AP 115N - 0200 - 2

**MARKER UNIT
(VIDEO MAP)
TYPE 30**

**GENERAL ORDERS AND
MODIFICATIONS**

FOR USE IN THE
ROYAL AIR FORCE

DRG. NO. AP2527R/B14/64

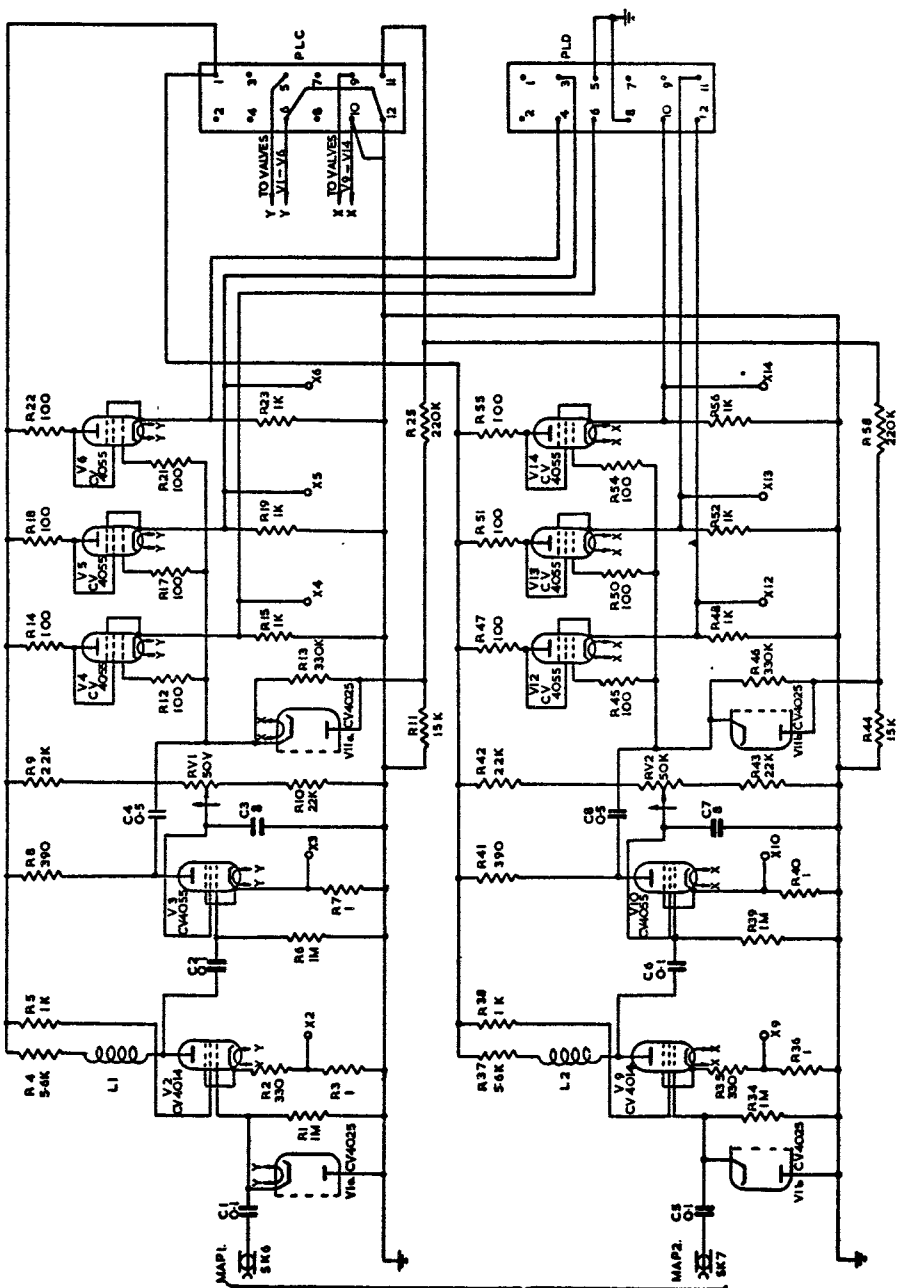
(4) Drill a new 5/32 in dia fixing hole in each lampholder bracket as shown on the drawing. Remove swarf and treat raw edges with Varnish Electrical Insulating Air Drying.

Drawing No. A.P.2527R/B.9/62

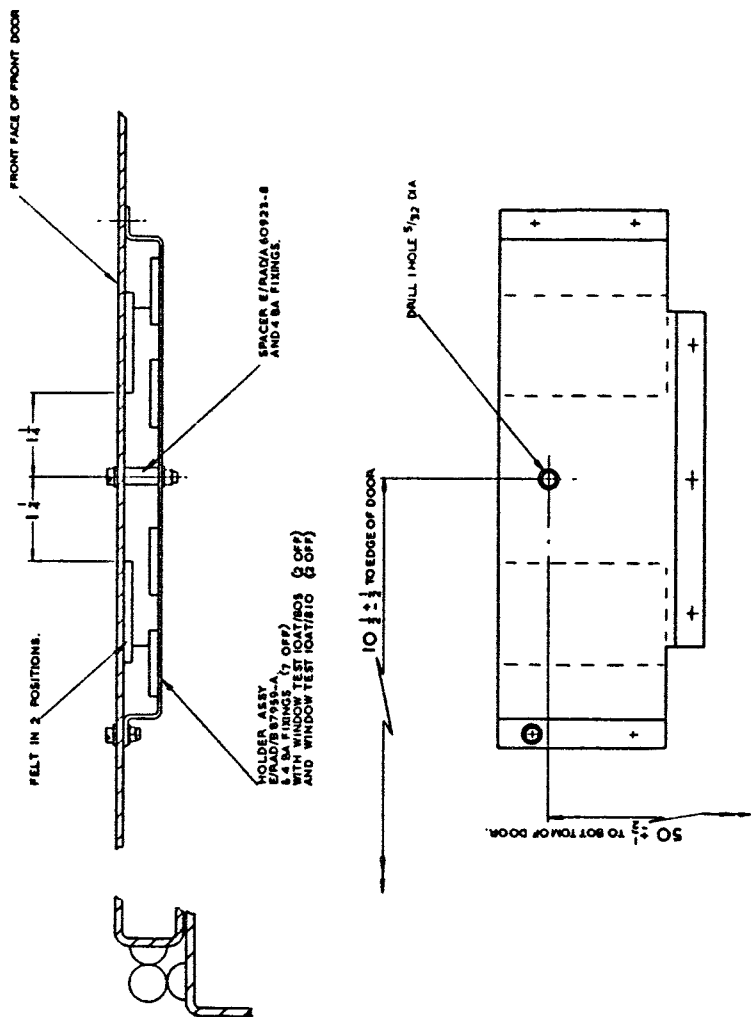
(2) At dimensions shown on the drawing drill 1 hole $\frac{3}{32}$ in. dia.

(3) Fit Holder Assembly, Part No. E/RAD/87959-A and Spacer, Part No. E/RAD/60923-8 and secure temporarily. Ensure that top of holder is horizontal. Using holder assembly as jig, drill seven holes through door using $\frac{3}{32}$ in. drill. Remove holder, de-burr holes and varnish raw edges.

(4) Using Adhesive (Ref. No. 33C/9436957) secure the two felt pads in position as shown on the drawing.

DRG. NO. AP2527R/38/62

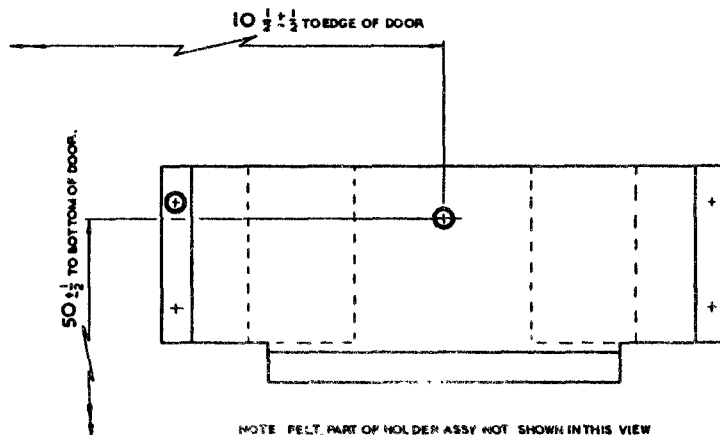
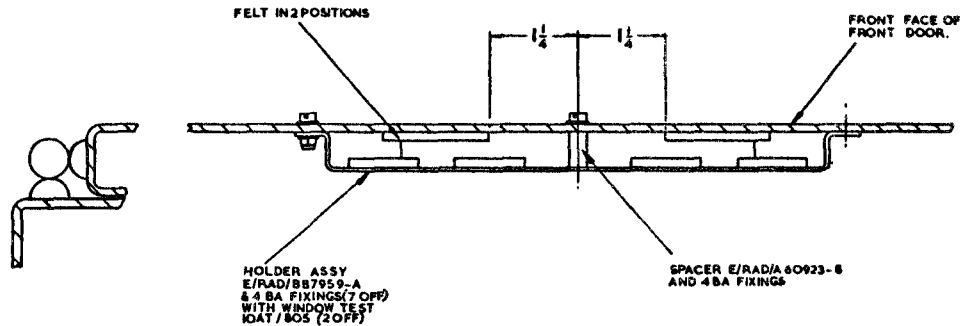
- (1) Open front door of Marker Unit (Video Map) 30 (Ref. No. 10D/18541), i.e., door which gives access to Indicating Unit 33, and lift door off hinges taking care not to loose spacing washers from hinge pins.
- (2) At dimensions shown on the drawing drill one hole 5/32 in. diameter.
- (3) Fit Holder Assembly W/RAD/87959-A and Spacer E/RAD/60903-8 and secure temporarily. Ensure that top of holder is horizontal. Using Holder assembly as jig, drill seven holes through door using 5/32 in. drill. Remove holder, de-burr holes and varnish raw edges.
- (4) Using Adhesive (Ref. No. 33C/9436957) secure in position as shown on the drawing the two felt pads.

- (5) Fit Holder Assembly E/RAD/B.87959-A and Spacer E/RAD/60923-8 and secure with 4 B.A. fixing material supplied.
- (6) Stow in holder assembly, two Window Test (Ref. No. 10AT/805) until required for use.
- (7) On completion of this modification delete the figure '1' from the unit modification record label.

DRG. NO A.P. 2527 R / B. 3 / 55

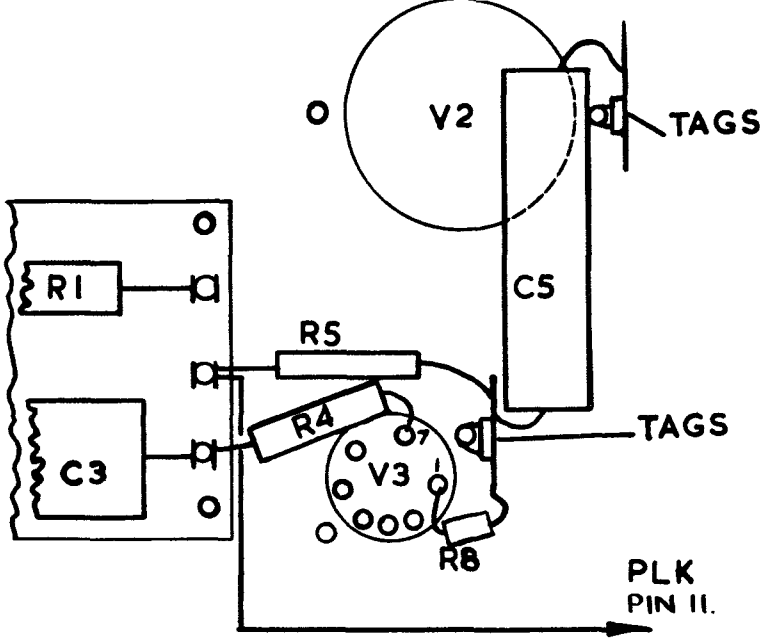
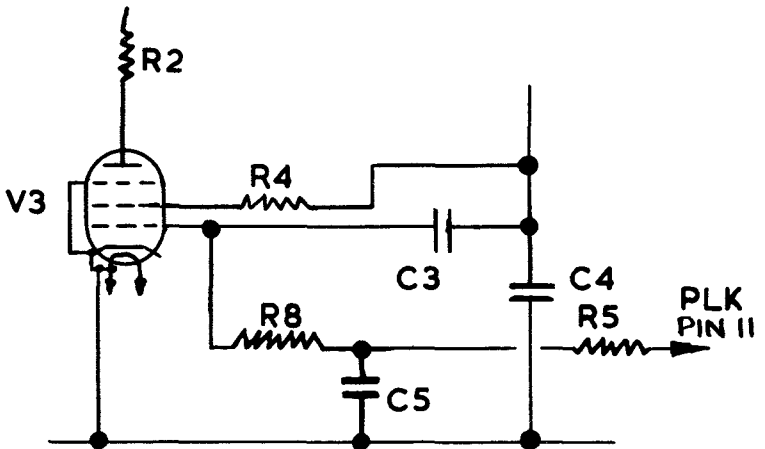
(1) Mount the two stand-off tags provided, one using the fixings of valve base V2 and the other using the fixings of valve base V3 as shown in the drawing.

(2) Disconnect resistor R5 from pin 1 of valve V3 and connect to tag as shown in the drawing.

(3) Connect the resistor R8, between pin 1 of valve V3 and tag, and the condenser C5 between the two tags as shown in the drawing.
